09/855,853

Office Action Summary

Claims 42-53,58,59,61,62,64,65,70 and 71 are rejected under 35 U.S.C. 102(e) as being anticipated by Tabuchi (PN 6,112,002).

FIG. 28A

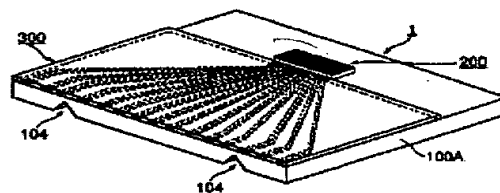
Figures 28A illustrates a semiconductor laser (200) and an optical waveguide (300) provided on substrate (100A) with aligning grooves (104). Figure 28B illustrates a substrate (120) provided with grooves for the optical fibers (3) and a common substrate (110) provided with alignment rails (111), as shown substrate (100A) and substrate (120) are mounted on the common substrate (110), where alignment of the semiconductor laser with the optical fibers is obtained via the alignment grooves and rails to establish optical coupling between the lasers and fibers. As illustrated these substrates are mounted horizontally and the laser radiation is in the y-coordinate direction.

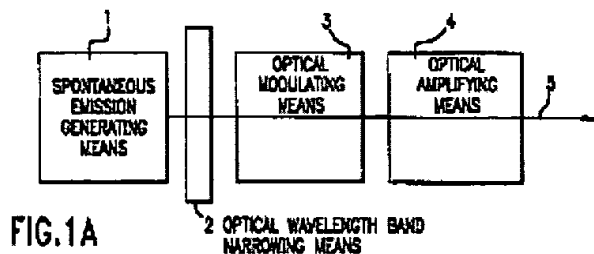
Tabuchi does not disclose coupling modulators, amplifiers and SOA with the array of lasers.

Coupling of optical modulators, optical amplifiers or any other optical element within a laser system is well known in the laser art and would be within the level of skill of any person having ordinary skill in the art, which understands the scientific and

engineering principles applicable to the claimed invention, as shown in figure 1A of Ota et al.
